December 4, 2017

RE: Comments in Response to November 6, 2017 LCFS Workshop and Draft Regulation

Figure 1. Comparison of "original" and "corrected" EER curves

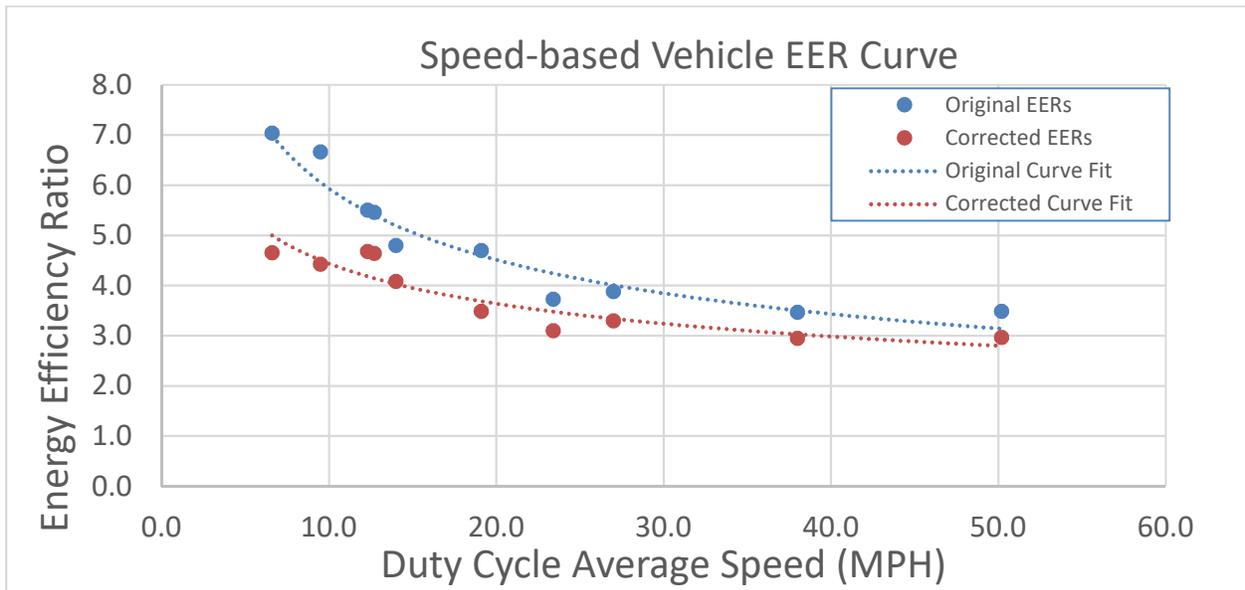
When these charging efficiencies are incorporated, the EER for electric vehicles decreases. The resulting values for the data points considered in the ICT paper are shown in Table 1. Plotting the corrected EER values in the same manner as done in the ICT paper shows the strong influence that both the charging efficiency and diesel drayage truck fuel economy assumptions have on the “EER curve” (see Figure 1). In fact, the updated curve suggests that, for an average vehicle speed of 12-15 mph, the EER is approximately 4.0 rather than the 5.0 proposed by Staff. This is consistent with the existing EER values for transit buses currently used in the LCFS program.

We also note that the ICT analysis was based on a limited set of test vehicles across many different vehicle types and duty cycles. Further, the EER curve was generated based on chassis dynamometer test cycles only and when the curve was compared to actual in-use data, the correlation was poor. Until more data are available in each vehicle category, ARB should adopt conservative EER values to avoid over-issuing credits.

1. Utilize an average fuel economy of the three tested diesel goods movement trucks in the SCAQMD study as the baseline for establishing the electric truck’s EER and adopting the average fuel economies for the near-dock, local, regional, and UDDS test cycles shown in Table 1.
2. Incorporate charging efficiencies into the EER assumptions for EVs.
3. Reevaluate the EER curve calculated by Staff and select an EER of approximately 4.0 for EVs with an average vehicle speed of 12-15 mph.
